# Access Compliance Report

## Public Rights-of-Way

### (Curb Ramps)

Intersection ID: 10025412	Main Street: E_CARSON_BV	Cross Street: N/A	Location:	N
ADA ID: 3BC610545ADE	Ramp Type: Perp	Initial Pass/Fail: Fail	Overall Compliance: No	Severity Score: 12.5
Codes/Mitigation Info/Possible Solution		Field Measurements/Component Compliance

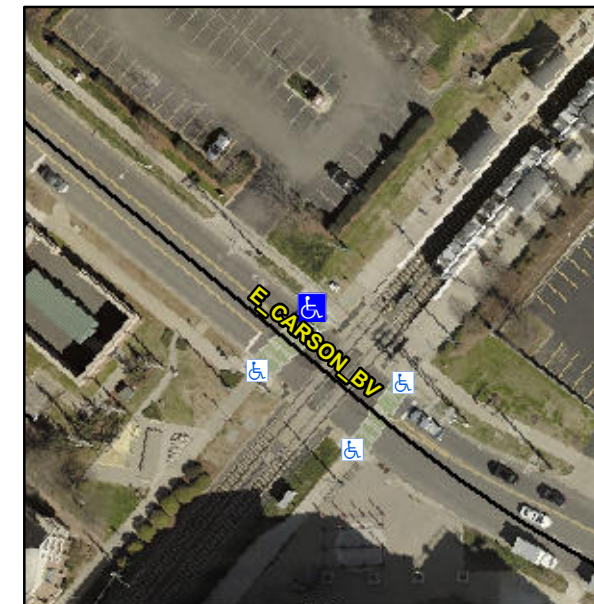
**Not Found, R304.2.2**

Compliance	Description	Data	Compliance	Description	Data
N/A	Ramp Length (in)	67.0	No	Ramp Slope (%)	8.6
Yes	Ramp Width (in)	98.0	Yes	Ramp XSlope (%)	0.4
N/A	Flare Type LT	N/A	N/A	Flare Type RT	N/A
N/A	Flare Slope LT (%)	N/A	N/A	Flare Slope RT (%)	N/A
N/A	Flare Traversable LT?	N/A	N/A	Flare Traversable RT?	N/A
N/A	Landing Length (in)	N/A	N/A	DWS Provided?	N/A
N/A	Landing Width (in)	N/A	N/A	DWS Contrast?	N/A
N/A	Landing Slope (%)	N/A	N/A	DWS Length (in)	N/A
N/A	Landing X Slope (%)	N/A	N/A	DWS Full Width?	N/A
N/A	Landing Curb? (Y/N)	N/A	N/A	DWS Offset (in)	N/A
N/A	Shared Landing?	N/A			
N/A	Gutter Ponding?	N/A	N/A	Gutter Slope (%)	N/A
N/A	Gutter Lip Ht (in)	N/A	N/A	Gutter X Slope (%)	N/A
N/A	Painted X Walk1?	Yes	N/A	Painted X Walk2?	N/A
	X Walk 1 Direction	To SW		X Walk 2 Direction	N/A
N/A	X Walk 1 Width (in)	161.0	N/A	X Walk 2 Width (in)	N/A
	X Walk 1 Slope (%)	2.9		X Walk 2 Slope (%)	N/A
	X Walk 1 X Slope (%)	0.6		X Walk 2 X Slope (%)	N/A

**Remove & Replace Entire Ramp.**
